646.9811
Job Sheet 165649

Part Name: Upper Deflector

ENGINEERING CHANGE NOTICE NO. 03828

DWG TITLE: DEFLECTOR

SHEET 1, ZONE A5-A6 & B5-B6 WAS:

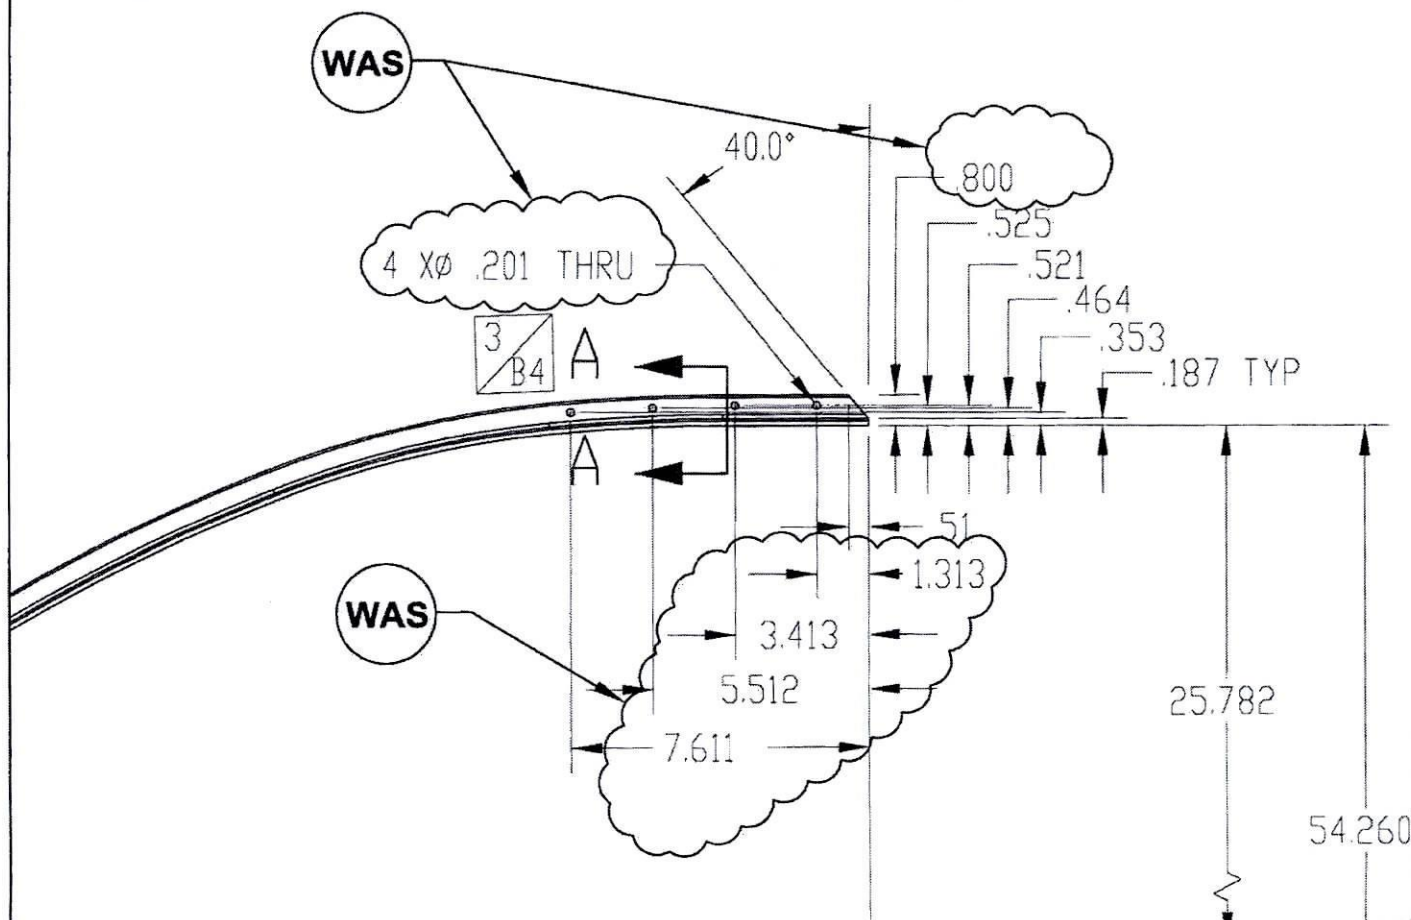
REASON: REVISED CORNER RADIUS, TOLERANCES, AND ADDED INSPECTION DIMENSIONS.
